# NRC Salt Waste Monitoring Open Item Status

**July 28, 2010**

SRR-CWDA-2010-00096

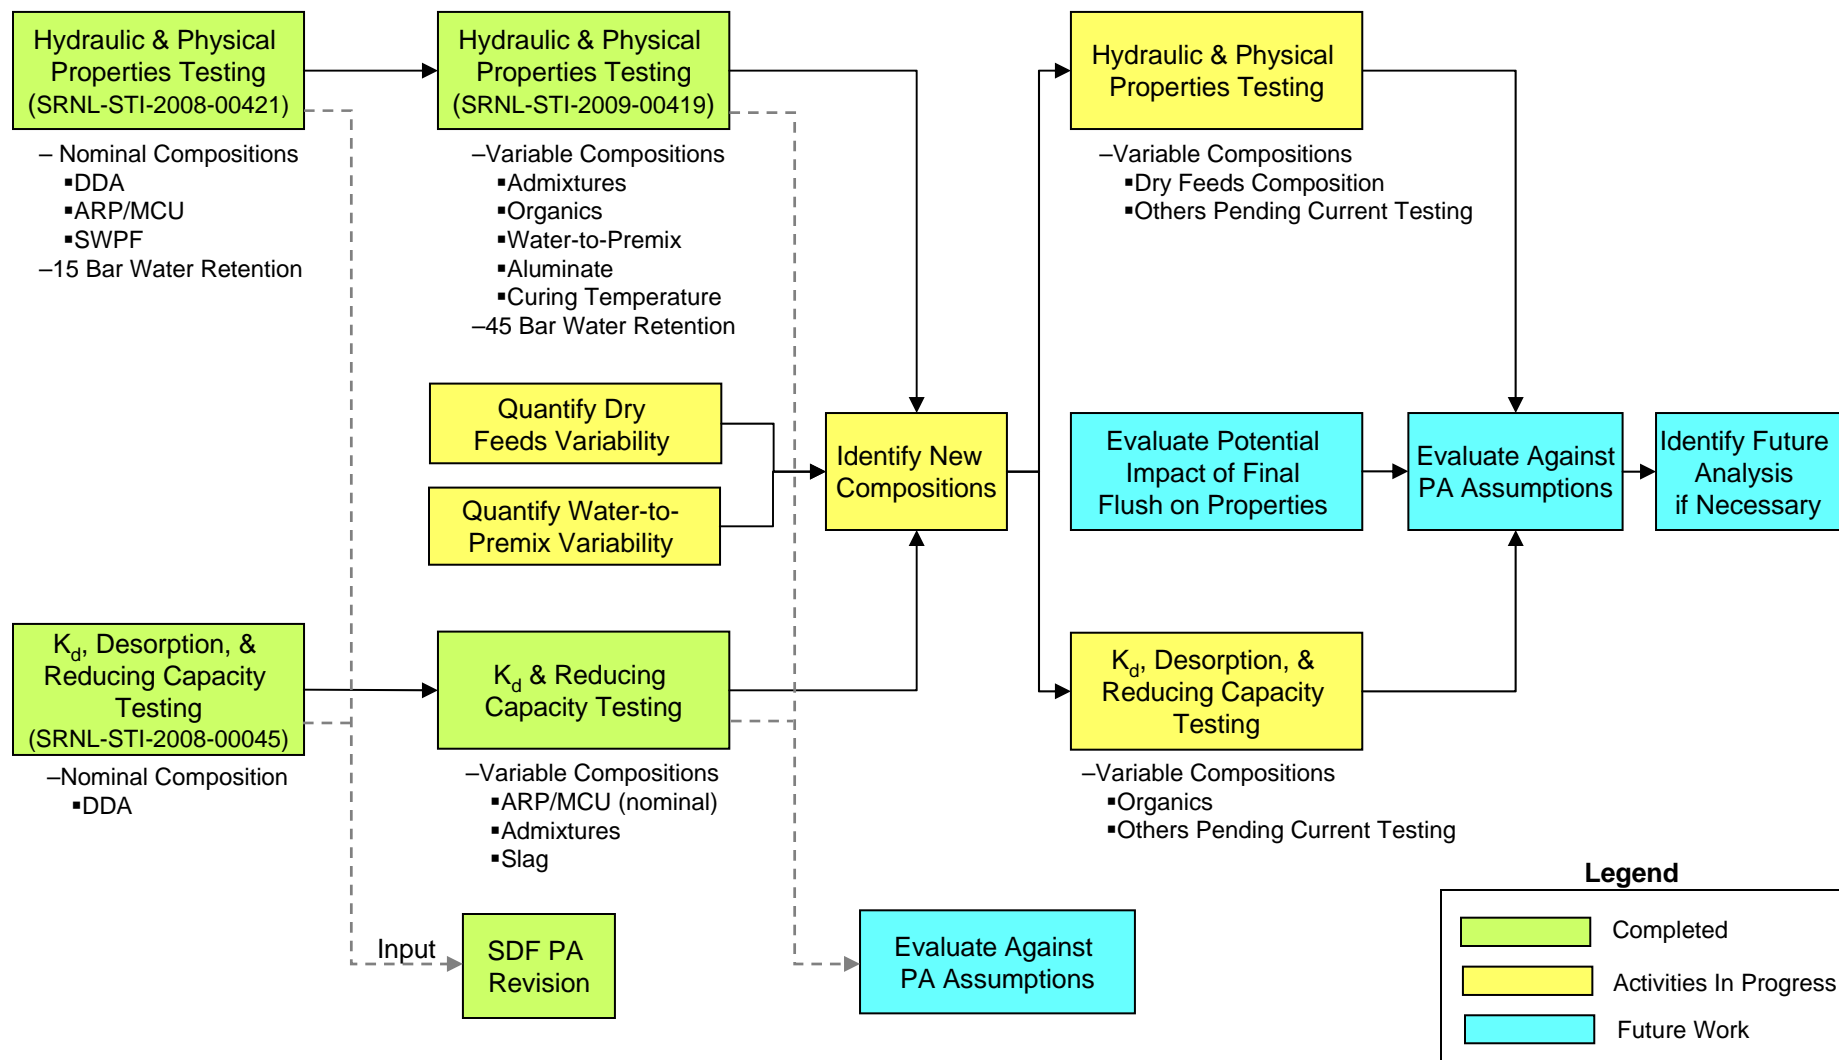
- *At the SRS Saltstone Facility, as a result of variations in the composition of saltstone grout actually produced at the SRS SPF, DOE should determine the hydraulic and chemical properties of as-emplaced saltstone grout*

- Core samples have been extracted from Vault 4 Cell E
- Laboratory analysis has been completed for density, porosity, x-ray diffraction, and scanning electron microscope. Results are consistent with simulants.
- Evaluation of core sample analysis results anticipated to be completed 3Q CY2010
- **Alternate sampling methods have been tested for future implementation**
- Integrated sampling plan outlining future sampling and correlation of laboratory prepared saltstone to as-emplaced saltstone will be developed and is anticipated to be implemented 4Q CY2010
